UNITED STATES
NUCLEAR REGULATORY COMMISSION

SUBJECT: ACCEPTANCE FOR REFERENCING OF COMBUSTION ENGINEERING OWNERS GROUP CE NPSD-1168, "JOINT APPLICATIONS REPORT FOR CONTAINMENT ISOLATION VALVE AOT EXTENSION" (TAC NO. MA6288)

The Combustion Engineering Owners Group (CEOG) submitted Joint Applications Report (JAR) CE NPSD-1168, dated June 1999, to justify a risk informed change in the technical specifications allowed outage time (AOT) for containment isolation valves (CIVs). The staff has completed its review of this report with the assistance of Scientech, Incorporated. The Scientech technical evaluation report (TER) is attached.

This report provides the results of the evaluation performed on the risk-informed application submitted by the Combustion Engineering Owners Group (CEOG) to extend the allowed outage time (AOT) for many containment isolation valves (CIVs) from 4 hours to 7 days in modes 1, 2, 3, and 4. The requested change applies to those CIVs addressed by Condition A and C of Section 3.6.3 of NUREG-1432, Revision 1. The joint applications report (JAR), CE NPSD-1168, cites the need for flexibility in the performance of on-line maintenance and surveillance testing as the

Figure 2: Schematic of Penetration Connected Directly to Containment Atmosphere and Outside Environment -- Penetration Path A1

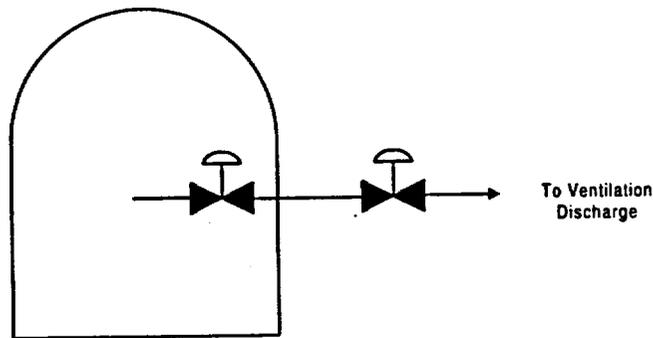
ID	Description of Penetration Flow Path	Calculation Method	Comment
A1	CIVs in penetrations connected directly to containment atmosphere and outside environment (See Figure 2)	<p>SINCE THE PIPING OUTSIDE CONTAINMENT IS OPEN, NO DIFFERENTIATION IS MADE BETWEEN SEISMIC AND NON-SEISMIC EVENTS</p> $SAOT_{LERF} = \Delta CDF * P_{CIV} * \frac{AOT}{8760} = 8.8E-9$ <p>where</p> <p>$SAOT_{LERF}$ = single AOT risk for large early release</p> <p>ΔCDF = change in CDF, baseline CDF assumed to be: 2E-4/yr</p> <p>P_{CIV} = failure probability of unaffected CIV (solenoid type): 2.3E-3</p> <p>$\frac{AOT}{8760}$ = fraction of full duration of AOT (i.e., 168 hours) to a year</p>	<p>Specific Assumptions:</p> <ul style="list-style-type: none"> • Inoperability of one CIV is detected during periodic surveillance or cycling of the valve. • The inoperable CIV is in the open position and the other CIV is the only barrier for releases to the environment. • The failure mechanism causing the operable CIV to open also prevents it from closing if a demand occurs. <p>REVIEW COMMENTS:</p> <ul style="list-style-type: none"> • The unaffected CIV is assumed to be OPERABLE. • It is assumed that the cause of the failure of the affected CIV is not shared by the redundant CIV. That is, common cause failure is absent. • The redundant valve is treated as same-as-new.

Figure 3: Schematic of Penetration Connected Directly to Containment Atmosphere and a Closed Loop System -- Penetration Path A2

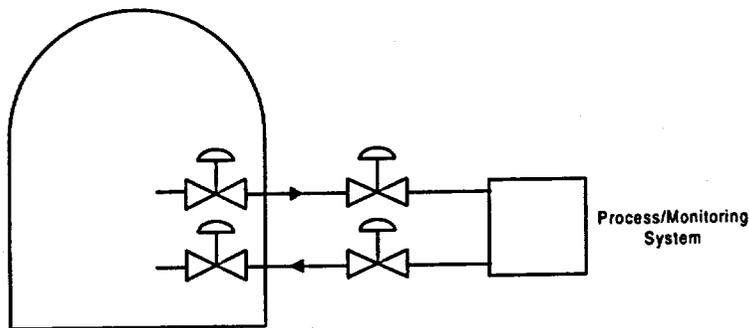
ID	Description of Penetration Flow Path	Calculation Method	Comment
A2	CIVs in penetrations connected directly to containment atmosphere and closed loop system outside environment (See Figure 3)	<p>NON-SEISMICALLY INITIATED EVENTS</p> $SAOT_{LERF} = \Delta CDF * P_{CIV} * P_{pi} \frac{AOT}{8760} = 1.5E-12$ <p>where</p> <p>$SAOT_{LERF}$ = single AOT risk for large early release</p> <p>ΔCDF = change in CDF, baseline CDF assumed to be: 2E-4/yr</p> <p>P_{CIV} = failure probability of unaffected CIV (air-operated): 3.85E-3</p> <p>P_{pi} = probability of a pipe failure in closed loop system: 1E-4</p> <p>$\frac{AOT}{8760}$ = fraction of full duration of AOT (i.e., 168 hours) to a year</p> <p>SEISMICALLY INITIATED EVENTS</p> $SAOT_{LERF} = \Delta CDF * P_{CIV} * \frac{AOT}{8760} = 1.3E-9$ <p>where</p> <p>ΔCDF = change in CDF, baseline CDF for seismic assumed to be: 1.75E-4/yr</p> <p>P_{CIV} = same as above</p> <p>$\frac{AOT}{8760}$ = fraction of full duration of AOT (i.e., 168 hours) to a year</p>	<p>Specific Assumptions:</p> <ul style="list-style-type: none"> • CIVs normally opened and cycled to satisfy in-service testing and TS requirements. • Inoperability of one CIV is detected during periodic surveillance or cycling of the valve and it is secured in open position when found to be inoperable. • CIVs may be either AOVs or solenoid-operated valves. • The inoperable CIV remains open for all conditions and demands. • Conditional failure probability is 1 following a seismic event for non-seismic piping systems. <p>REVIEW COMMENTS:</p> <ul style="list-style-type: none"> • The unaffected CIV is assumed to be OPERABLE. • Crediting close loop system as a barrier is applicable to cases in which the affected valve (the valve under CM) is intact. If not true, the value of $SAOT_{LERF}$ of 1.5E-12 increases to 1.5E-8.

Figure 4: Schematic of Penetration Connected to Containment Atmosphere and an Open Loop System -- Penetration Path A3

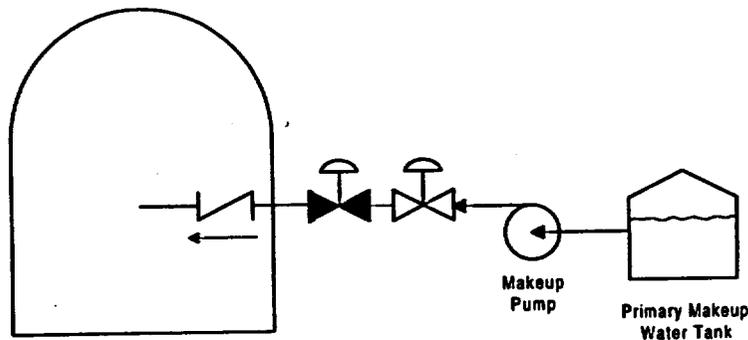
ID	Description of Penetration Flow Path	Calculation Method	Comment
A3	CIVs in penetrations connected directly to containment atmosphere and open loop system outside environment (See Figure 4)	<p>NON-SEISMICALLY INITIATED EVENTS</p> $SAOT_{LRF} = \Delta CDF * P_{CK} * P_B \frac{AOT}{8760} = 5.83E-13$ <p>where</p> <p>$SAOT_{LRF}$ = single AOT risk for large early release</p> <p>ΔCDF = change in CDF, baseline CDF assumed to be: 2E-4/yr</p> <p>P_{CK} = failure probability of unaffected CIV (check valve): 1.52E-3</p> <p>P_B = probability of a pipe failure in open loop system: 1E-4</p> <p>$\frac{AOT}{8760}$ = fraction of full duration of AOT (i.e., 168 hours) to a year</p> <p>SEISMICALLY INITIATED EVENTS</p> $SAOT_{LRF} = \Delta CDF * P_{CK} * \frac{AOT}{8760} = 5.1E-10$ <p>where</p> <p>ΔCDF = change in CDF, baseline CDF for seismic assumed to be: 1.75E-4/yr</p> <p>P_{CK} = same as above</p> <p>$\frac{AOT}{8760}$ = fraction of full duration of AOT (i.e., 168 hours) to a year</p>	<p>Specific Assumptions:</p> <ul style="list-style-type: none"> • CIVs are check valve inside containment and AOV outside containment. Failure of a check valve is 1.52E-3 per demand. • Inoperability of one CIV is detected during periodic surveillance or cycling of the valve and it is secured in open position when found to be inoperable. • For outside containment, there are multiple valves for isolation of a break and failure of multiple valves is assumed to be a low probability event and has no impact. • Pipe break cannot be isolated. • Piping outside the containment is non-seismically qualified and probability of pipe failure after a seismic event is 1.0. <p>REVIEW COMMENTS:</p> <ul style="list-style-type: none"> • The unaffected CIV is assumed to be OPERABLE. • In this case although the loop is open, the analysis effectively assumes a closed loop system by crediting other means of isolation as shown in term P_B. • As in the case of A2, crediting close loop system as a barrier is applicable to cases in which the affected valve (the valve under CM) is intact.

Figure 5: Schematic of Penetration Connected to Closed Loop Inside and Outside Containment -- Penetration Path A4

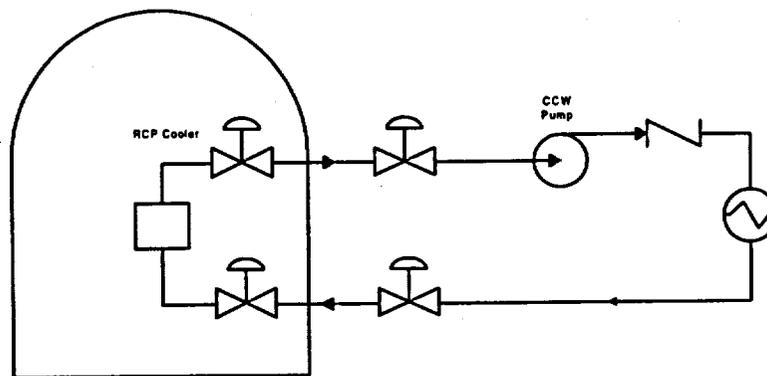
ID	Description of Penetration Flow Path	Calculation Method	Comment
A4	CIVs in penetrations connected directly to closed loop system inside and outside containment (See Figure 5)	<p>NON-SEISMICALLY INITIATED EVENTS</p> $SAOT_{LERF} = \Delta CDF * P_{CIV} * P_{IH} * P_{IO} \frac{AOT}{8760} \ll 2E-13$ <p>where</p> <p>$SAOT_{LERF}$ = single AOT risk for large early release</p> <p>ΔCDF = change in CDF, baseline CDF assumed to be: 2E-4/yr</p> <p>P_{CIV} = failure probability of unaffected CIV (air-operated): 3.85E-3</p> <p>P_{IH} = probability of a pipe failure in close loop system inside containment: 1E-4</p> <p>P_{IO} = probability of a pipe failure or inadvertent opening of a relief valve in closed loop outside containment: 6E-4</p> <p>$\frac{AOT}{8760}$ = fraction of full duration of AOT (i.e., 168 hours) to a year</p> <p>FOR SEISMICALLY INITIATED EVENTS</p> $SAOT_{LERF} = \Delta CDF * P_{CIV} * \frac{AOT}{8760} = 1.3E-9$ <p>where</p> <p>ΔCDF = change in CDF, baseline CDF for seismic assumed to be: 1.75E-4/yr</p> <p>P_{CIV} = same as above</p> <p>$\frac{AOT}{8760}$ = fraction of full duration of AOT (i.e., 168 hours) to a year</p>	<p>Specific Assumptions:</p> <ul style="list-style-type: none"> Inoperability of one CIV is detected during periodic surveillance of the valve and it is secured in open position when found to be inoperable. Piping (inside and outside) is non-seismically qualified and has a conditional failure probability of 1.0 for seismic events. A breach in the piping of both inside and outside containment must fail concurrently with failure to isolate the penetration for a pathway to the environment. Inadvertent opening of a relief valve will also breach the piping outside of containment and is given a probability of 5.0E-4 for the proposed AOT. AOV failure probability includes failure of the valve to close on demand or to remain closed during the proposed AOT. <p>REVIEW COMMENTS:</p> <ul style="list-style-type: none"> The unaffected CIV is assumed to be OPERABLE. Crediting close loop system outside containment as a barrier is applicable to cases in which the affected valve (the valve under CM) is intact. If not true, the value of $SAOT_{LERF}$ would increase by a factor of 1.0E4.

Figure 6: Schematic of Penetration Connected to SI Line Leakage Path -- Penetration Path B1

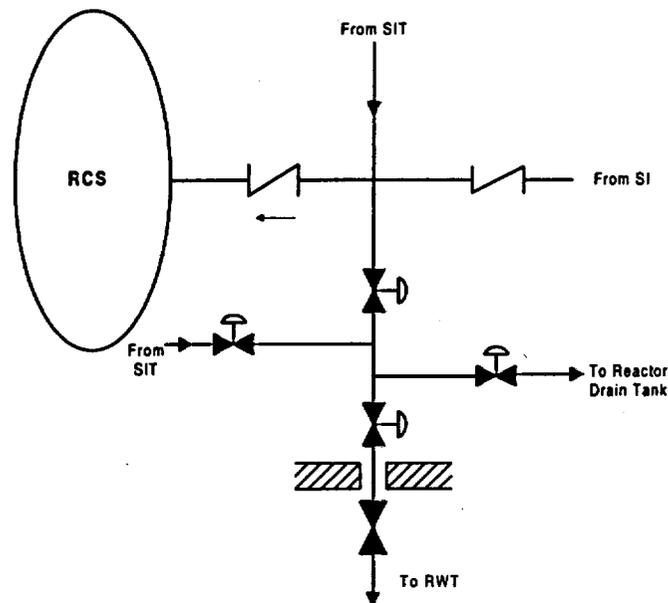
ID	Description of Penetration Flow Path	Calculation Method	Comment
B1	CIVs in penetrations connected to Safety Injection (SI) line check valve leakage path (See Figure 6)	$ISLOCA = \frac{\lambda_1 \lambda_2 \lambda_3 T^2}{3} + \lambda_1 \lambda_2 \lambda_{d1} \left[\frac{d_2 T + 1}{2} \right] + \lambda_1 \lambda_{d2} \lambda_3 T \left[\frac{d_3 T + 1}{2} \right]$ $+ 2 \lambda_1 \lambda_{d2} \lambda_{d1} \left[\frac{d_2 T + 1}{2} \right] \left[\frac{d_3 T + 1}{2} \right] = 2.19E-8 \text{ per year}$ $SAOT_{LRF} = ISLOCA \cdot \frac{AOT}{8760} = 4.19E-10$ <p>where,</p> <p>$SAOT_{LRF}$ = single AOT risk for large early release</p> <p>$ISLOCA$ = frequency of interfacing system LOCA per year: 2.19E-8 per year</p> <p>λ_1 = random leakage rate of SI check valve: 8.76E-4 per year</p> <p>λ_2 = random leakage rate of AOV: 7.0E-3 per year</p> <p>λ_3 = random leakage rate of manually operated valve: 1.68E-3 per year</p> <p>λ_{d2} = probability of the AOV failing to reset: 1.55E-3 per demand</p> <p>λ_{d1} = probability of the manually operated valve failing to reset: 3.88E-4 per demand</p> <p>d_2 = the number of times the AOV is operated: 4</p> <p>d_3 = the number of times the manually operated valve is operated: 4</p> <p>T = fault exposure time: 1 year</p> <p>$\frac{AOT}{8760}$ = fraction of full duration of AOT (i.e., 168 hours) to a year</p>	<p>Specific Assumptions:</p> <ul style="list-style-type: none"> Assumed that penetration has one AOV on inside and one manually operated valve on outside the containment. The inoperability of the AOV is detected during surveillance or cycling of the valve. The failure mode of manually operated valves is not known but failure to reset is bounded by a failure on demand of 3.88E-4 per demand. Average of four in-service tests of the manual CIV per year. Mean failure rate of an AOV transferring open is 7.98E-7 per hour and a bounding probability to fail on demand of 1.55E-3. The AOV is cycled once per quarter. Random leakage of a SI check valve is assumed to be 8.76E-4. Fault exposure time is equivalent to time that the plant operates in its non-cold shutdown modes, namely one year. A pressure transmitter can detect a leaking or stuck open SI check valve. <p>REVIEW COMMENTS:</p> <ul style="list-style-type: none"> The unaffected CIV is assumed to be OPERABLE. Without taking credit of the pressure transmitter, the result can change significantly. It appears that the expression used to estimate ISLOCA frequency is unnecessary complex. Verification of the correctness of the equation was not performed. It is recommended that the applicant fully derive the equation presented and provide additional discussion. The expression used in the JAR does not account for common cause failure of redundant valves.

Figure 7: Schematic of Penetration Connected to RCS Sample Line -- Penetration Path B2

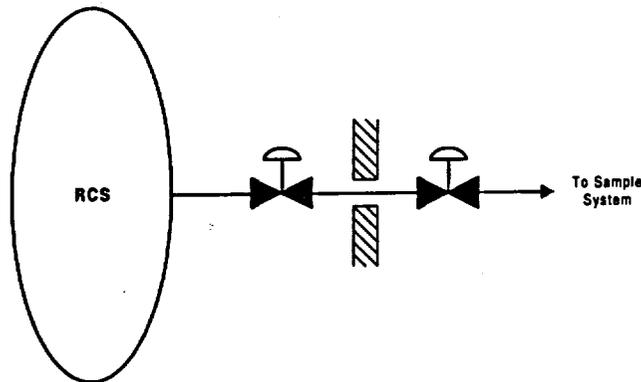
ID	Description of Penetration Flow Path	Calculation Method	Comment
B2	CIVs in penetrations connected to the reactor coolant system (RCS) sample line (See Figure 7)	$SAOT_{LERF} = CCDP_{SL} * F_P * P_{FRC} * \frac{AOT}{8760} = 8.23E - 10$ <p>where,</p> <p>$SAOT_{LERF}$ = single AOT risk for large early release</p> <p>$CCDP_{SL}$ = total conditional core damage probability given the interaction of a small LOCA: 3.73E-3</p> <p>F_P = frequency of a random pipe failure occurring in the sample system creates a small LOCA: 5.0E-3 per year</p> <p>P_{FRC} = probability of the operable CIV failing to remain closed during the proposed AOT: 2.3E-3</p> <p>$\frac{AOT}{8760}$ = fraction of full duration of AOT (i.e., 168 hours) to a year</p> <p>FOR SEISMIC EVENTS:</p> <p>$SAOT_{LERF} = 6.57E - 10$</p>	<p>Specific Assumptions:</p> <ul style="list-style-type: none"> • Both CIVs are AOVs. • CIVs assumed to be cycled daily and initially closed. Probability to remain closed is more conservative than failing to close on demand. • The same failure mechanism causing the CIV to transfer open prevents it from closing on demand. • Pipe failure due to exposure to high RCS temperature and pressure is negligible. • A break in the sample system can be compensated by charging system or ECCS and the plant can be shutdown in a timely manner so it will not lead to core damage. • Note: $CCDP_{SL} * F_P$ is equivalent to core damage frequency associated with a sample system pipe failure (1.9E-5). • Assumed exposure time used for P_{FRC} is equal to AOT. This assumption is not conservative. The exposure time should be the time between the last test to the end of AOT. <p>REVIEW COMMENTS:</p> <ul style="list-style-type: none"> • The unaffected CIV is assumed to be OPERABLE. • It is assumed that the cause of the failure of the affected CIV is not shared by the redundant CIV. That is, common cause failure is absent. • The redundant valve is treated as same-as-new.

Figure 8: Schematic of Penetration Connected to Letdown Line -- Penetration Path B3

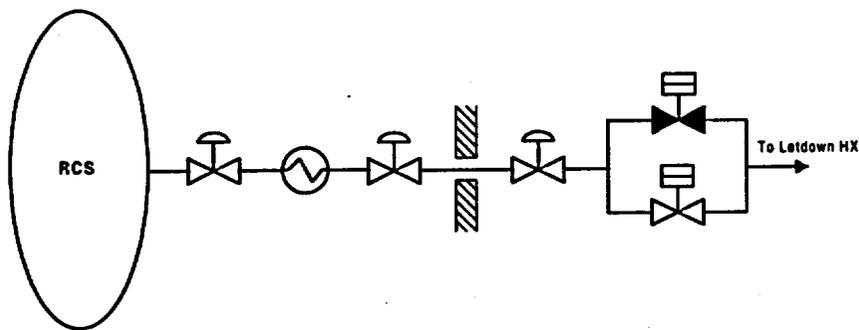
ID	Description of Penetration Flow Path	Calculation Method	Comment
B3	CIVs in penetrations connected to Letdown or reactor coolant pump (RCP) bleed-off line (See Figure 8)	<p>BREAK INSIDE CONTAINMENT:</p> $SAOT_{LERF} = ICCDP * P_{FTC}$ $= \left[CCDP_{SL} * F_p * P_{FTC} * \frac{AOT}{8760} \right] * P_{FTC}$ $= (5.54E-10) * (1.55E-3) = 8.59E-13$ <p>BREAK OUTSIDE CONTAINMENT:</p> $SAOT_{LERF} = ICCDP = F_p * P_s * \frac{AOT}{8760}$ $= 7.82E-9$ <p>where</p> <p>$SAOT_{LERF}$ = single AOT risk for large early release</p> <p>$ICCDP$ = incremental conditional core damage probability</p> <p>$CCDP_{SL}$ = total conditional core damage probability given the interaction of a small LOCA: 3.73E-3</p> <p>F_p = frequency of a random pipe failure occurring in the letdown line inside or outside containment: 5.0E-3/yr for inside and 2.63E-3/yr for outside</p> <p>P_{FTC} = probability of the remaining CIVs failing to closed by common cause during the proposed AOT: 1.55E-3</p> <p>P_s = probability of both CIVs failing to closed during the proposed AOT: 1.55E-4</p> <p>$\frac{AOT}{8760}$ = fraction of full duration of AOT (i.e., 168 hours) to a year</p>	<p>Specific Assumption:</p> <ul style="list-style-type: none"> • All valves are AOVs and AOV failure to close is 1.55E-3. • Failure of the actuation signal to close the AOV is negligible when compared with hardware failures. • Inoperability of one CIV can be detected and secured in open position. The two other AOVs can isolate the containment. • Break is assumed between the two CIVs inside containment and the one downstream of the regenerative heat exchanger is inoperable and in the open position. • Breach in outside line is downstream of the outside CIV from piping failure or failure of a relief valve (probability of 2.13E-2 per year). • The probability of both operable CIVs failing to close is dominated by common cause failure for a probability of 1.55E-4. <p>REVIEW COMMENTS:</p> <ul style="list-style-type: none"> • In the text, the equation for a break outside containment has CLERP not ICLERP. This is assumed to be a typo. • The unaffected CIV is assumed to be OPERABLE. • For this situation, the licensee may be able to enter the LCO by removing two CIVs. It is recommended that guidance be provided that only one CIV of a pair could be removed at a time.

Figure 9: Schematic of Penetration Connected to Non-Essential Cooling Units -- Penetration Path C1

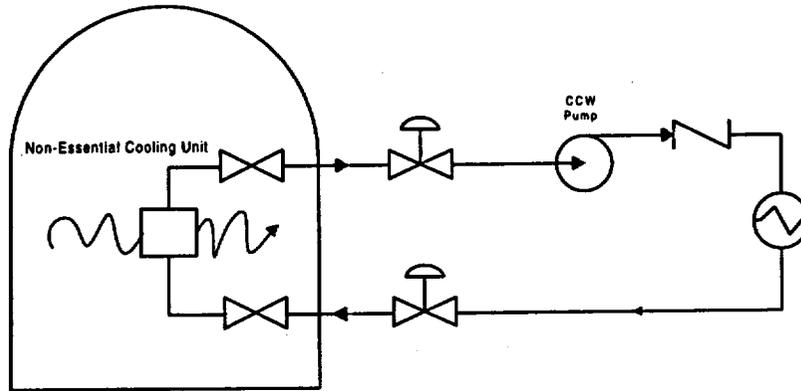
ID	Description of Penetration Flow Path	Calculation Method	Comment
C1	CIVs in penetrations connected to non-essential containment cooling (See Figure 9)	<p>CASE INVOLVING A RANDOM PIPE FAILURE AND CAUSING REACTOR SCRAM:</p> $SAOT_{CIV} = ICCDP = CCDP_T * F_p * \frac{AOT}{8760}$ $= 3.07E - 9$ $SAOT_{LERF} = ICCDP * P_R$ $= 1.84E - 12 \text{ (without } P_F \text{)}$ <p>CASE INVOLVING A PIPE FAILURE CONCURRENT WITH CORE DAMAGE:</p> $SAOT_{LERF} = \Delta CDF * P_F * P_R * \frac{AOT}{8760}$ $= 2.30E - 13$ <p>where</p> <p>$SAOT_{CIV}$ = single AOT risk for core damage</p> <p>$SAOT_{LERF}$ = single AOT risk for large early release</p> <p>$CCDP_T$ = conditional core damage probability due to reactor trip: 6.08E-6</p> <p>$ICCDP$ = incremental conditional core damage probability</p> <p>ΔCDF = change in CDF, baseline CDF assumed to be: 2E-4/yr</p> <p>F_p = frequency of breaching a closed loop system outside the containment: 2.63E-2 per year</p> <p>P_F = probability of a pipe failure in the closed loop system inside the containment: 1.0E-4</p> <p>P_R = probability of a pipe failure in the closed loop system outside the containment: 6.0E-4</p> <p>$\frac{AOT}{8760}$ = fraction of full duration of AOT (i.e., 168 hours) to a year</p>	<p>Specific Assumptions:</p> <ul style="list-style-type: none"> • One AOV per penetration and is open during normal operation. • Inadvertent opening of a relief valve will also breach the piping outside of containment and is given a probability of 5.0E-4 for the proposed AOT. The combination of relief and piping failure yield a probability of 6.0E-4. • A breach in the piping of both inside and outside containment must fail for a pathway to the environment. <p>REVIEW COMMENTS:</p> <ul style="list-style-type: none"> • The equation for the case involving a pipe failure and causing reactor scram may need to have a probability for pipe failure outside containment to complete the pathway to the environment (P_F). • The unaffected CIV is assumed to be OPERABLE. • A breach in the closed loop system during power operation is assumed to cause an uncomplicated reactor trip. • The presented analysis is valid if the breach does not impact the CCW function.

Figure 10: Schematic of Penetration Connected to Steam Generator -- Penetration Path C2

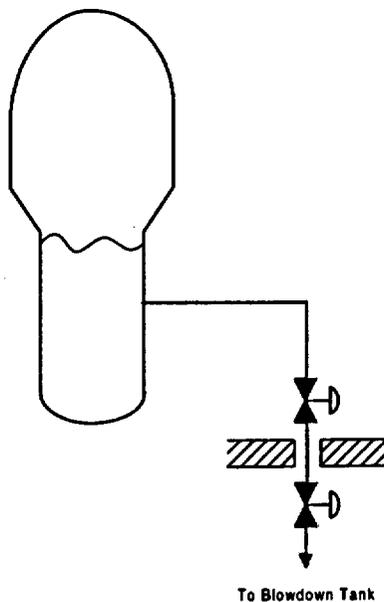
ID	Description of Penetration Flow Path	Calculation Method	Comment
C2	CIVs in penetrations connected to secondary side of steam generator (See Figure 10)	$SAOT_{LERF} = CCDP_{SGTR} * P_{FRC} * F_R * \frac{AOT}{8760}$ $= 2.02E-10$ <p>where</p> <p>$SAOT_{LERF}$ = single AOT risk for large early release</p> <p>$CCDP_{SGTR}$ = conditional core damage probability due to SGTR: 9.16E-4</p> <p>P_{FRC} = probability of the operable CIV failing to remain closed during the proposed AOT: 2.3E-3</p> <p>F_R = random pipe failure of blowdown piping outside the containment: 5.0E-3 per year</p> <p>$\frac{AOT}{8760}$ = fraction of full duration of AOT (i.e., 168 hours) to a year</p>	<p>Specific Assumptions:</p> <ul style="list-style-type: none"> • A penetration has two closed AOVs and once one is determined inoperable, it is secured open. • For a path to the environment, a SGTR event must also occur concurrently with a transfer opening of the closed CIV. • The piping outside of the containment is non-seismically qualified. <p>REVIEW COMMENTS:</p> <ul style="list-style-type: none"> • The unaffected CIV is assumed to be OPERABLE. • It is assumed that the cause of the failure of the affected CIV is not shared by the redundant CIV. That is, common cause failure is absent. • The redundant valve is treated as same-as-new.

Figure 11: Schematic of Penetration Connected to Containment Instrument Sensor -- Penetration Path D

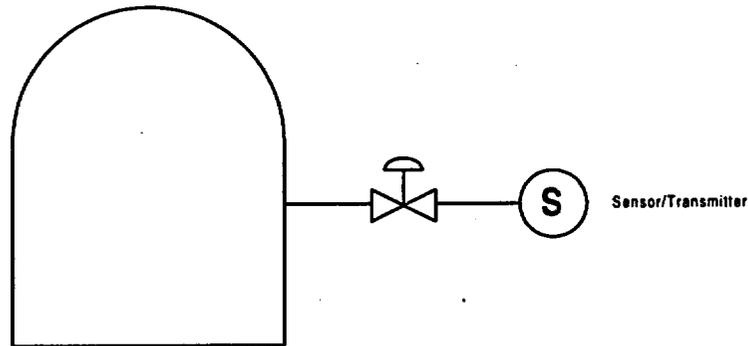
ID	Description of Penetration Flow Path	Calculation Method	Comment
D	CIVs in penetrations connected to containment atmosphere pressure detector (See Figure 11)	No equations, qualitative assessment	Proposed by CEOG to be negligible and well below acceptance criteria of 5.0E-7 and 5.0E-8 for ICCDP and ICERLP respectively.
E1	CIVs in penetrations used to support RCS inventory control safety function under accident condition (See Figure 12)	<p>HPSI/LPSI LINE:</p> $ISLOCA = \frac{\lambda^2 T}{2} + \lambda \lambda_d \left[\frac{dT + 1}{2} \right]$ $SOAT_{LRF} = ISLP = ISLOCA * P_C * \frac{AOT}{8760}$ $= 1.68E-9$ <p>where</p> <p>$SAOT_{LRF}$ = single AOT risk for large early release</p> <p>ISLP = incremental conditional ISLOCA probability</p> <p>ISLOCA = frequency of interfacing system LOCA per year: 8.76E-7</p> <p>λ = random leakage rate of SI check valve: 8.76E-4 per year</p> <p>λ_d = probability of the second check valve failing to reset: 2.81E-4 per demand</p> <p>d = the number of times the check valve is operated: 3</p> <p>P_C = conditional probability of pipe failure following exposure to RCS pressure: 0.1</p> <p>T = fault exposure time: 1 year</p> <p>$\frac{AOT}{8760}$ = fraction of full duration of AOT (i.e., 168 hours¹) to a year</p>	<p>Specific Assumptions:</p> <ul style="list-style-type: none"> Assumed that penetration has two check valves on inside and one MOV on outside the containment. The inoperability of the MOV is detected during surveillance or cycling of the valve. Piping upstream of the MOV can fail if exposed to RCS pressure with a conditional probability of 0.1. A pressure transmitter can detect a leaking or stuck open SI check valve. Random leakage of a SI check valve is assumed to be 8.76E-4. Average of three cold-shutdowns per year where the SI check valves are operated. Fault exposure time is equivalent to time that the plant operates in its non-cold shutdown modes, namely one year. <p>REVIEW COMMENTS:</p> <ul style="list-style-type: none"> Without taking credit of the pressure transmitter, the result can change significantly. It appears that the expression used to estimate ISLOCA frequency is unnecessary complex. Verification of the correctness of the equation was not performed. It is recommended that the applicant fully derive the equation presented and provide additional discussion. In this case although the loop is open, the analysis effectively assumes a closed loop system by crediting other means of isolation as shown in term P_C. Crediting close loop system as a barrier is applicable to cases in which the affected valve (the valve under CM) is intact.

Figure 13: Schematic of Penetration Connected to Charging Line -- Penetration Path E2

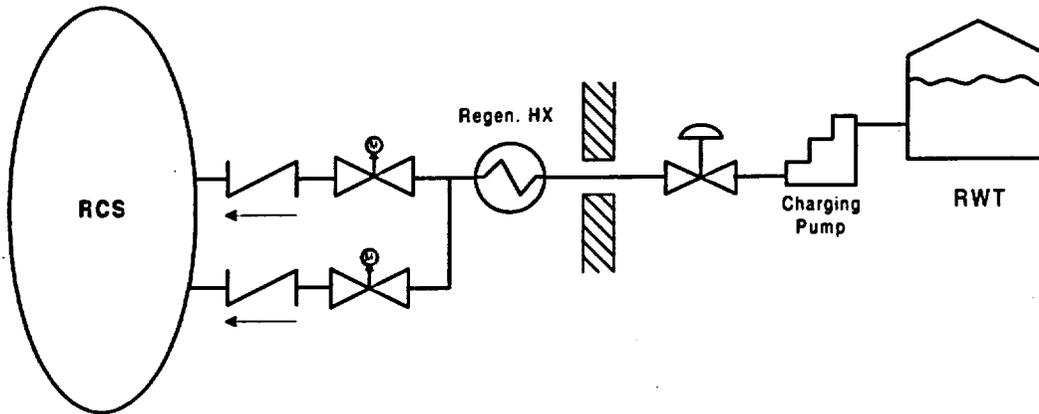
ID	Description of Penetration Flow Path	Calculation Method	Comment
E2	CIVs in penetrations used to provide charging under normal condition (See Figure 13)	No equations, qualitative assessment	Proposed by CEOG to be negligible and well below acceptance criteria of 5.0E-7 and 5.0E-8 for ICCDP and ICERLP respectively.
E3	CIVs in penetrations used to support containment heat removal function using containment sprays (See Figure 14)	$SAOT_{LERF} = \Delta CDF * P_{CK} * P_R * \frac{\Delta OT}{8760}$ $= 5.83E - 13$ <p>where</p> <p>$SAOT_{LERF}$ = single AOT risk for large early release</p> <p>ΔCDF = change in CDF, baseline CDF assumed to be: 2E-4/yr</p> <p>P_{CK} = probability of a pipe failing to isolate the associated containment penetration: 1.52E-3</p> <p>P_R = probability of a pipe failure in the open loop system outside the containment: 1.0E-4</p> <p>$\frac{\Delta OT}{8760}$ = fraction of full duration of AOT (i.e., 168 hours) to a year</p>	<p>Specific Assumptions:</p> <ul style="list-style-type: none"> • The containment penetration has one MOV outside and a check valve inside the containment where the MOV is the CIV that fails and is secured in the open position. • Based on the previous assumption, a redundant means of isolating the containment will be lost during the AOT of 7 days. • Random pipe failure outside the containment leads to the unavailability of the affected train of containment spray and a potential pathway to the environment. • Mean probability of a check valve to close is 1.52E-3. <p>REVIEW COMMENTS:</p> <ul style="list-style-type: none"> • In this case although the loop is open, the analysis effectively assumes a closed loop system by crediting other means of isolation as shown in term P_R. • As in the case of E1, crediting close loop system as a barrier is applicable to cases in which the affected valve (the valve under CM) is intact.

Figure 15: Schematic of Penetration Connected to Safety-Related Cooling Water Line -- Penetration Path E4

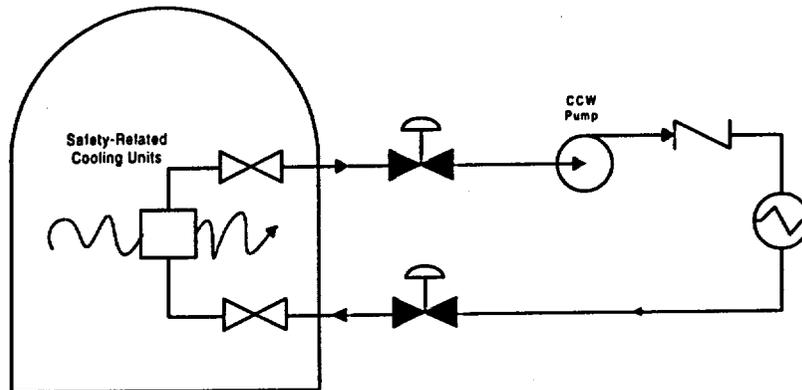
ID	Description of Penetration Flow Path	Calculation Method	Comment
E4	CIVs in penetrations used to support containment heat removal function using fan coolers (See Figure 15)	$SAOT_{LERF} = \Delta CDF * P_F * P_R * \frac{AOT}{8760}$ $= 2.30E-13 \text{ for closed loop}$ $= 3.84E-10 \text{ for open loop}$ <p>where</p> $SAOT_{LERF} = \text{single AOT risk for large early release}$ $\Delta CDF = \text{change in CDF, baseline CDF assumed to be: } 2E-4/\text{yr}$ $P_F = \text{probability of a pipe failing to isolate the associated containment penetration: } 1.0E-4$ $P_R = \text{probability of a pipe failure in the closed loop system outside the containment: } 6.0E-4 \text{ (closed loop), or } 1.0 \text{ (open loop)}$ $\frac{AOT}{8760} = \text{fraction of full duration of AOT (i.e., 168 hours) to a year}$	<p>Specific Assumptions:</p> <ul style="list-style-type: none"> • The containment penetration has a MOV on the outside and a normally open manually operated valve inside the containment where the MOV is the CIV that fails and is secured in the open position. • Only a random piping failure can establish a pathway from containment to the environment with a conditional probability of 1.0E-4 during the proposed AOT. • Inadvertent opening of a relief valve will also breach the piping outside of containment and is given a probability of 5.0E-4 for the proposed AOT. • A breach in the piping of both inside and outside containment must fail for a pathway to the environment. • Securing the MOV in the closed position will result in an action per TS. The proposed AOT for an inoperable CCS cooling water line CIV is 7 days: <p>REVIEW COMMENTS:</p> <ul style="list-style-type: none"> • The unaffected CIV is assumed to be OPERABLE. • Crediting close loop system outside containment as a barrier is applicable to cases in which the affected valve (the valve under CM) is intact. If not true, the value of $SAOT_{LERF}$ would increase by approximately three orders of magnitude.
